Submission to DA 2020/0474 Extension of Woombah Woods Caravan Park

SUBJECT: DA2021/0184 - 54 ILUKA ROAD WOOMBAH SUBMISSION

This is a submission on application DA2021/0184 for Proposed manufactured housing. I oppose the application in its present form.

Existing Remnant Koala Food Trees

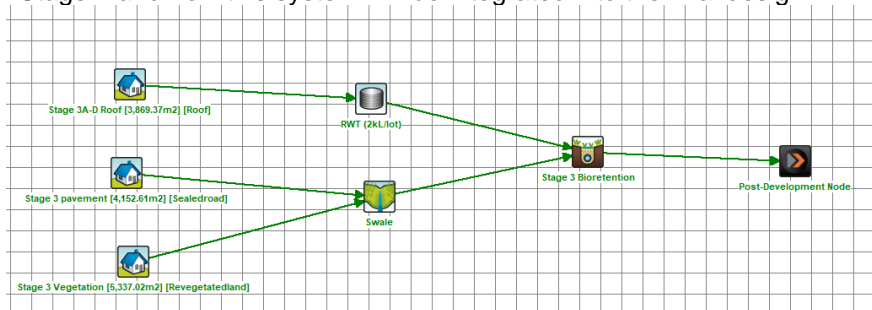
The proposal for 115 manufactured homes continues the destruction of the natural features of the site encouraged by council with its abrogation of responsibilities in permitting the uncontrolled expansion of the site resulting in prime koala habitat being destroyed. Expansion of use results as *death by 100 cuts* of valuable natural habitat which supported part of a viable koala population due to council's apparent inability to control development approval conditions. The application report depicts wooded area in west but not the case due to clearing and inability for council to enforce its draft koala management plan.

Council appears to have retrospectively approved expansion of the use under DA2017/0038 as well as dubiously permitting "lawful" clearing of koala habitat under DA83/464 contrary to koala management plan approved 2015 (still to be approved by the state). Koala habitat and food trees still exists on the property and if the council is serious regarding the implementation of its koala

management plan, it must protect the remaining habitat which is destined for removal by this proposal. All vegetation but for a token small area proposed as an ineffective buffer to the properties in the south, will be removed to cater for effluent disposal construction, resulting in a stark barren landscape for the overcrowded village lacking contemporary social planning features.

Stage 3 treatment train diagram

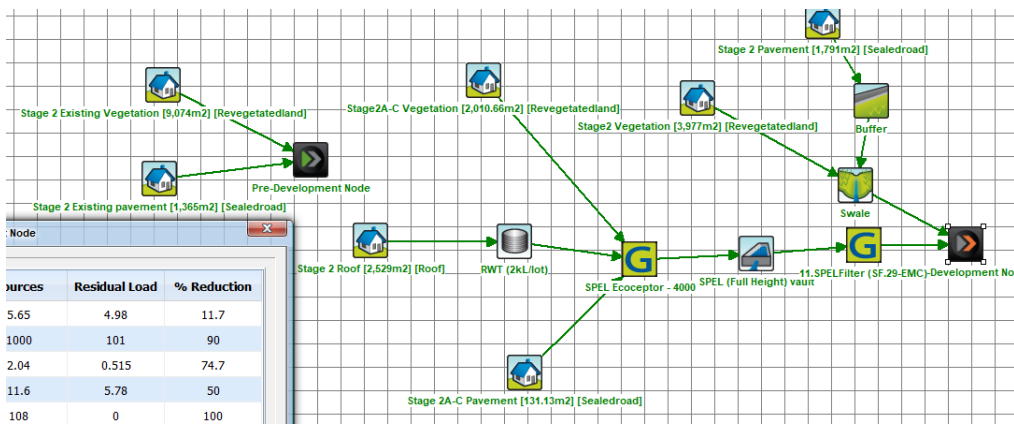
The stormwater report is confusing with the schematic for Stage 2 showing Stage 3 sections with a Stage 3 bioretention system. This creates the question as to what the Stage 2 system will be, requiring clarification for Stage 2 and how this system will be integrated into the final design.

The Stage 3 schematic depicts a completely different system with no bioretention system implied for Stage 2 which infers this section of the complex has only a swale system prior to discharge to the receiving environment. The Drawing Number J1128_SK01 continues this confusion.

The Stage 3 main system appears comprehensive but needs to be verified by council. It is recommended that an electronic version of the applicants MUSIC model be obtained, to do this as it is known that input data may provide an apparently acceptable outcome which needs to be checked. The SPEL filter system will achieve good results if sized, operated and maintained correctly. In addition to general regular cleaning, the filter cartridges require replacement periodically to ensure the predicted performance is achieved continuously. Council should condition annual reports from an independent organisation such as SPEL or its local representative, to verify the appropriate maintenance of the system. If not cleaned appropriately as recommended by SPEL, the system will fail to produce the claimed outcome.
